**Tanner's Creek Fly Ash  
Pond Assessment Report**

**June 2009**

In response to the coal combustion waste (CCW) impoundment failure at the TVA/Kingston coal-fired electric generating station in December of 2008, the Environmental Protection Agency has initiated a nationwide program of structural integrity and safety assessments of CCW impoundments or "management units". A CCW management unit is defined as a surface impoundment or similar diked or bermed management unit or management units designated as landfills that receive liquid-borne material and are used for the storage or disposal of residuals or by-products from the combustion of coal, including, but not limited to, fly ash, bottom ash, boiler slag, or flue gas emission control residuals. Management units also include inactive impoundments that have not been formally closed in compliance with applicable federal or state closure/reclamation regulations. The administration of this program is being supported by Lockheed Martin, who has authorized O'Brien & Gere to provide actual site specific impoundment assessments at selected facilities. This project is being conducted in accordance with the terms of Purchase Order No. 710

FLY ASH POND  
PLAN DIAGRAM

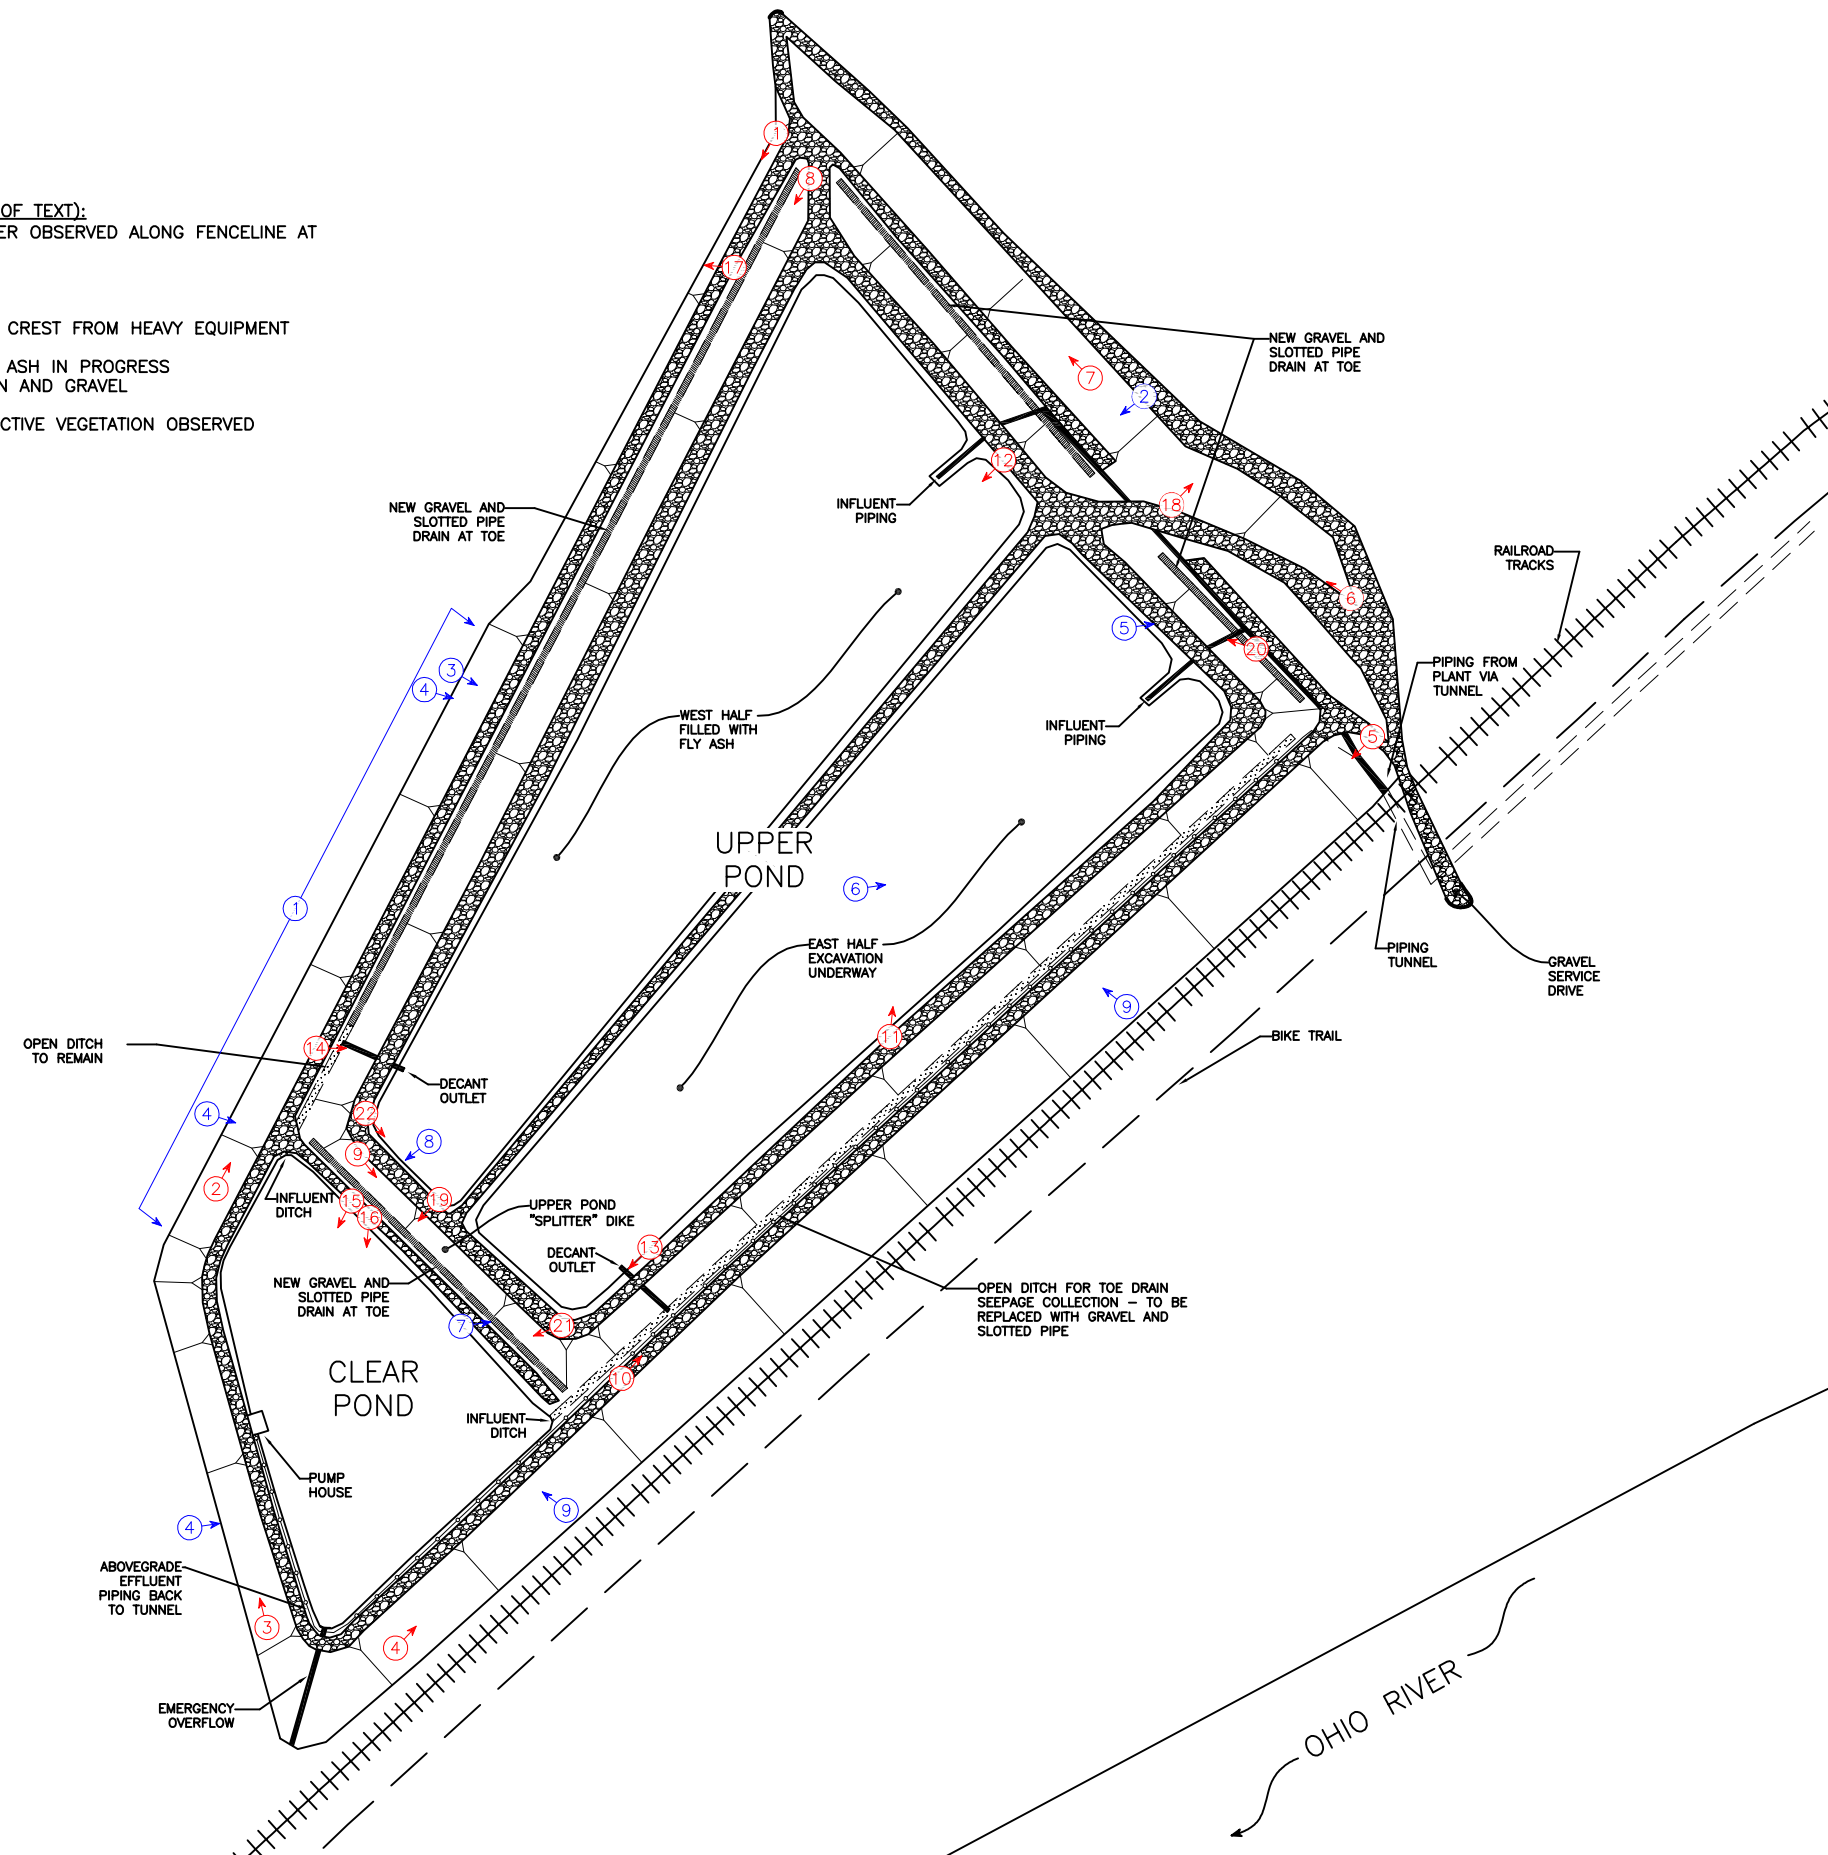
The following is a summary of observations made during the visual inspection. Figure 3 depicts the locations of the observations listed below.

- Shrubbery and trees up to 4-inch diameter are located along the fence line at the toe of the west slope.
- Animal burrows were noted at various locations on the west and south slopes of the original embankment

- An isolated seep of clear water was observed on the north slope near the construction access road (Appendix B - Photo 20).
- Areas rutted by equipment and missing vegetative cover were observed at two locations on the east slope of the original embankments.

- Minor elevation differences were noted along the crest of the Upper Pond due to heavy equipment traffic.
- Excavation of deposited fly ash was observed at the Upper Pond (Appendix B – Photo 11).

- Installation of the new slotted seepage collection system was observed along the splitter dike (Appendix B – Photo 21).
- Minor scarps were observed along the top of the upstream side of the east and south embankment slopes of the Upper Pond. Scarps are typically three feet in height and are made more prominent by the addition of roadway aggregate on the embankment crest (Appendix B – Photo 22).

1. SHRUBBERY AND TREES UP TO 4" DIAMETER OBSERVED ALONG FENCELINE AT TOE OF WEST EMBANKMENT
2. ISOLATED SEEP
3. MULTIPLE ANIMAL BURROWS
4. ANIMAL BURROW UNDER FENCE
5. ELEVATION DIFFERENCES OBSERVED ALONG CREST FROM HEAVY EQUIPMENT TRAFFIC
6. OBSERVED EXCAVATION OF DEPOSITED FLY ASH IN PROGRESS
7. OBSERVED INSTALLATION OF SLOTTED DRAIN AND GRAVEL
8. MINOR SCARPS OBSERVED
9. EQUIPMENT RUTS AND REMOVAL OF PROTECTIVE VEGETATION OBSERVED

SUBJECT  
PLAN SKETCH - FLY ASH POND

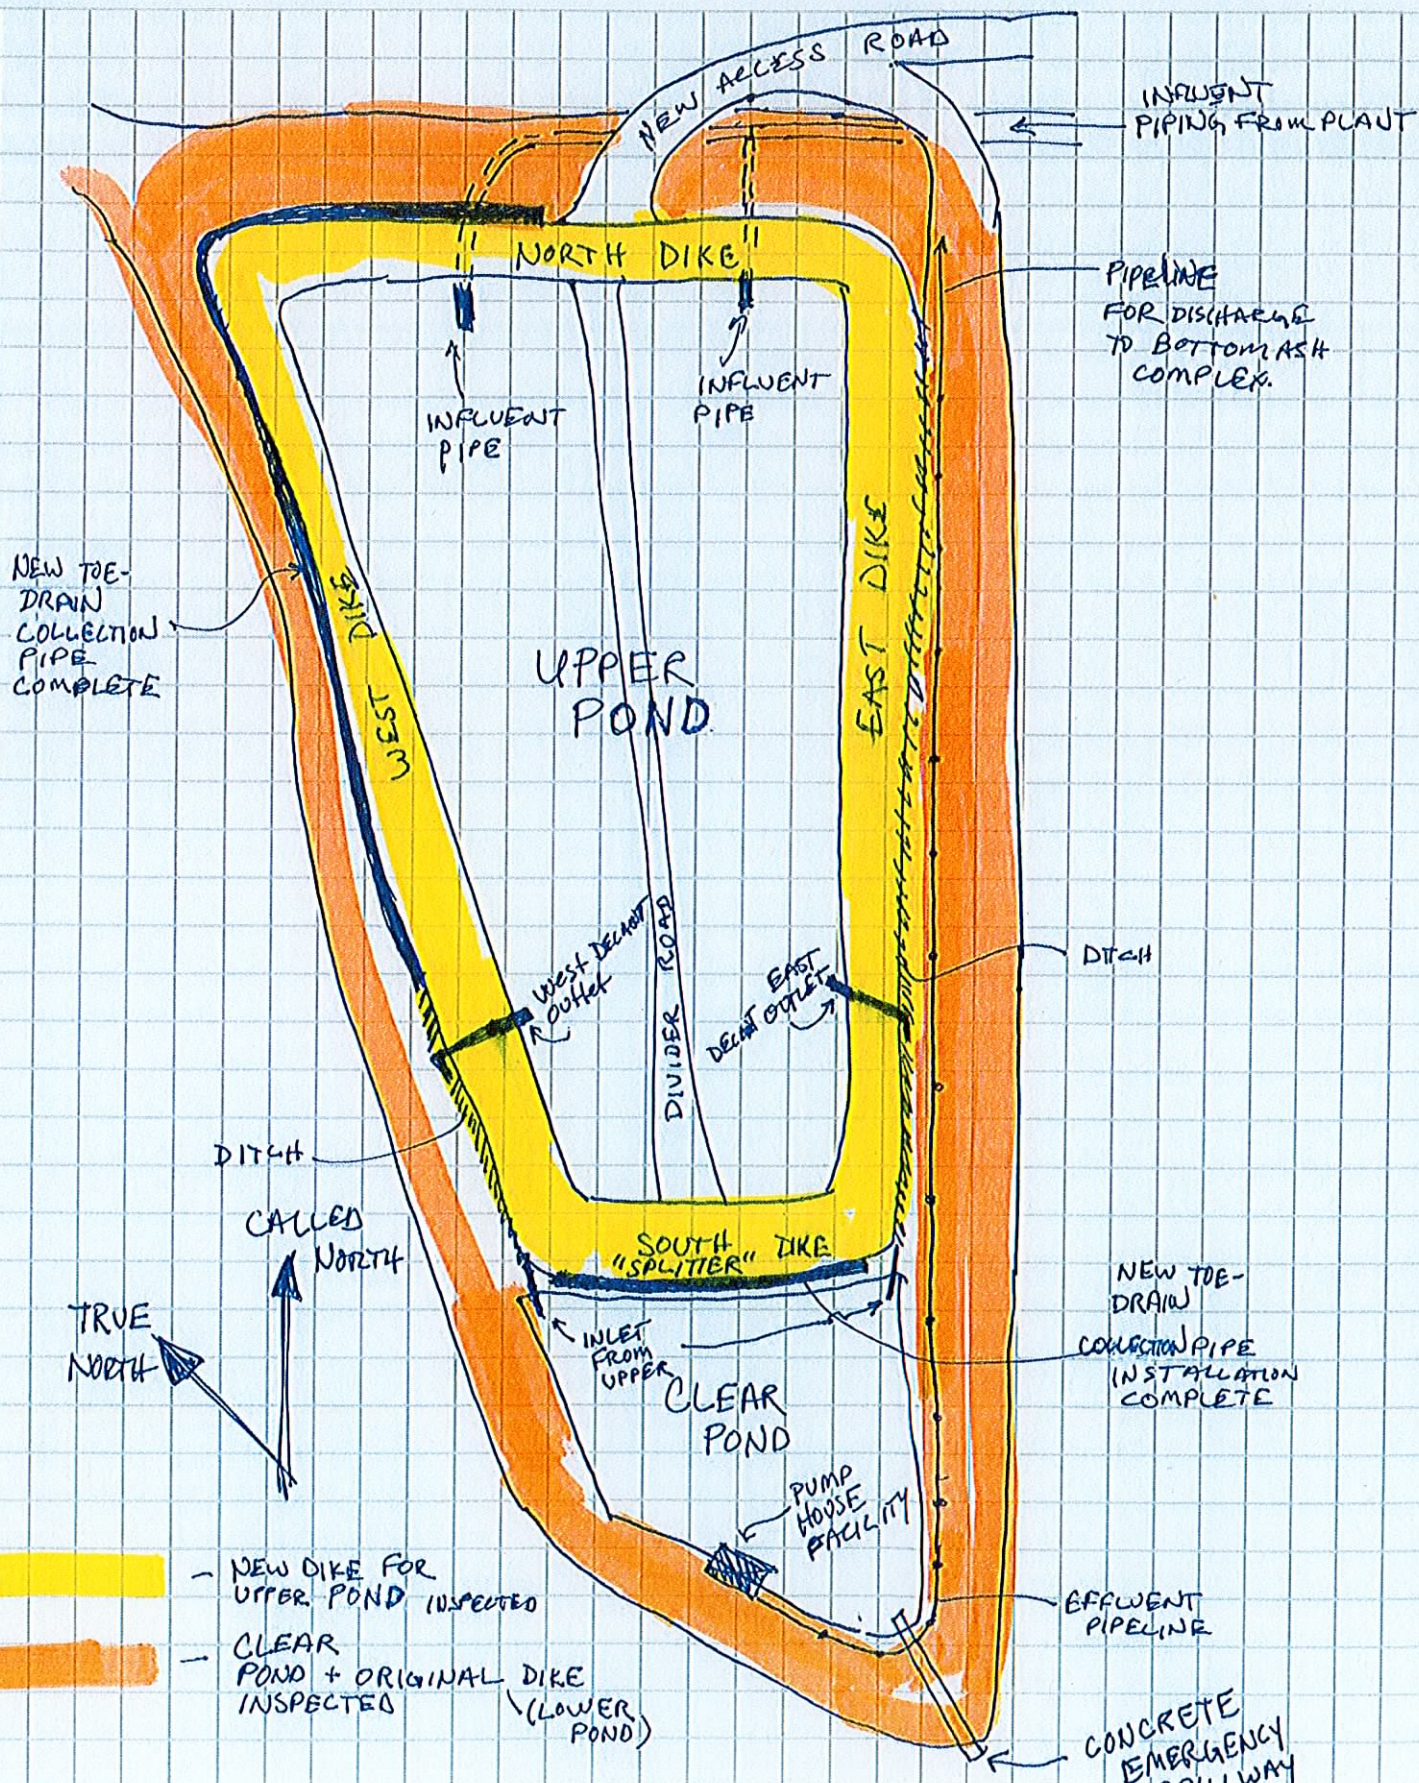
Inspection Issue #	Comments
1	Impoundment is inspected monthly by plant personnel and annually by a PE from corporate engineering staff
3	Outlet structures (2) have stop logs which can be added to the structures to raise decant elevation
4	No emergency spillway, only two decant outlets
6	13 piezometers located around the impoundment are measured and recorded monthly. 8 settlement plates located along the impoundment crest are surveyed quarterly.
8	The dike forming the upper pond is constructed on top of the previous fly ash deposits. According to plant personnel, no vegetation was present at the time of construction.
11	Minor elevation differences were noted along the crest due to heavy equipment traffic from recent excavation of settled ash. The plant reported that the surface grade of the crest will be restored upon completion of excavation activities.
12	No trashracks exist for the decant outlet structures

17	Numerous minor scarps were observed along the top of the upstream side of the 'east' and 'south' embankment slopes. Scarps are typically 3' in height and are made more prominent by the addition of roadway aggregate on the embankment crest.
20	Fly Ash Pond not in operation at time of inspection
21	The base of the dike is constructed with a porous gravel toe drain that is designed to collect embankment seepage. A slotted drainpipe is currently being installed at downstream toe around perimeter of dike to replace the existing ditch which conveys the embankment seepage to the outlet.
23	During inspection, the upper pond was filled to capacity with fly ash and fully drained of free surface water. However, when receiving new fly ash, or in an extreme precipitation event, the level of the clear pond (lower pool) may be elevated and this water may rest against the toe of the 'south' (splitter) dike.

SUBJECT  
PLAN SKETCH - FLY ASH POND

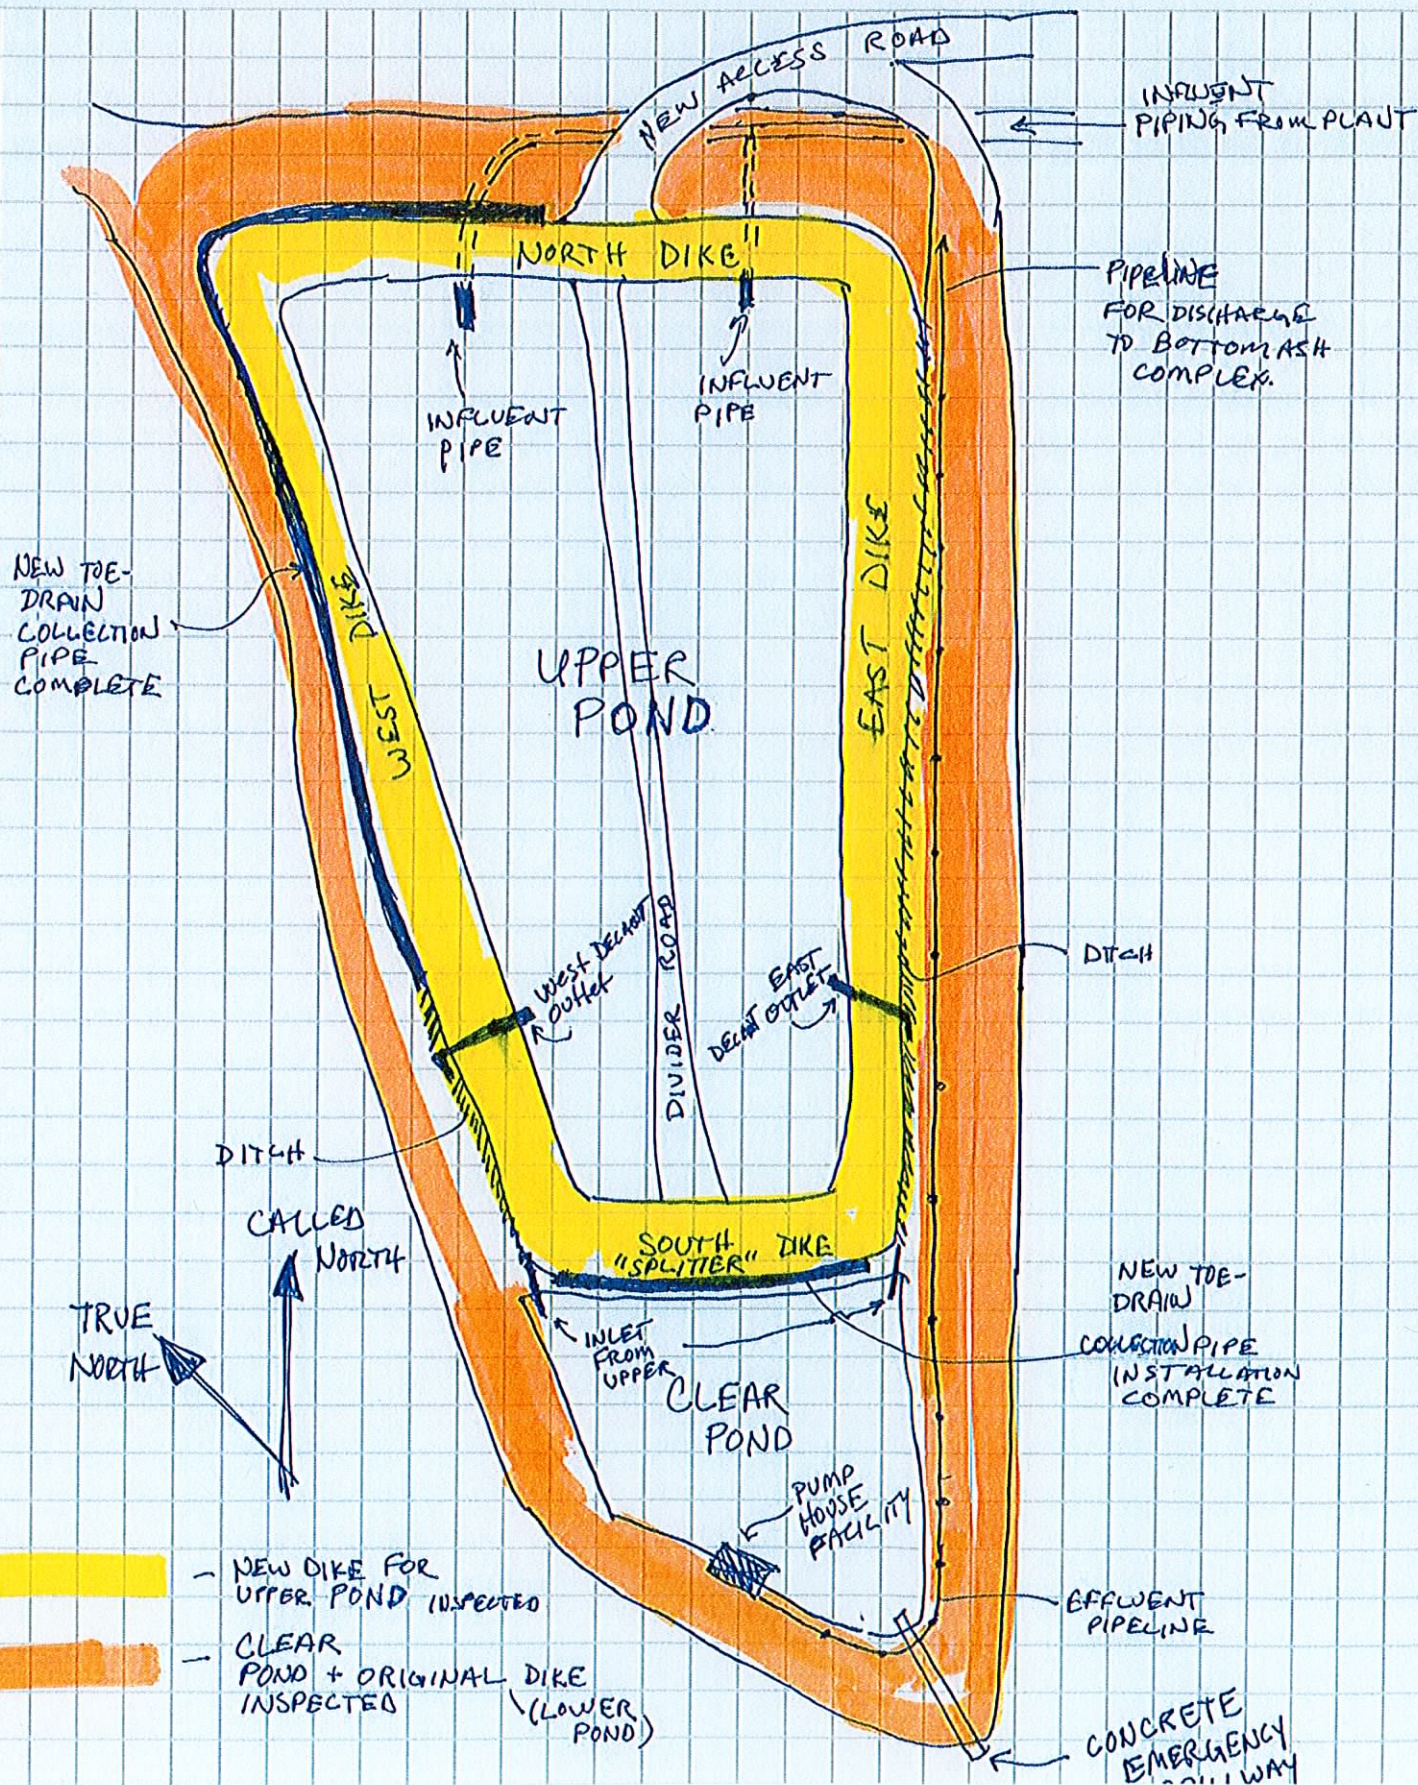
Inspection Issue #	Comments
1	Impoundment is inspected monthly by plant personnel and annually by a PE from corporate engineering staff
6	21 surface monitoring points located along the impoundment slopes and six slope indicators are surveyed quarterly. Additionally, the flow from the pumping operation is recorded in the plant's electronic records system.
8	A summary of 1970's construction reports indicated that the area was cleared to construct the original dike.
9	Shrubery with diameters up to approximately 4" are located along the fenceline at the toe of the west slope.
12	The pump inlets are protected and maintained to prevent blockage
20	Fly Ash Pond not in operation at time of inspection
21	An isolated minor seep of clearwater was observed on the north slope near the new construction access road.
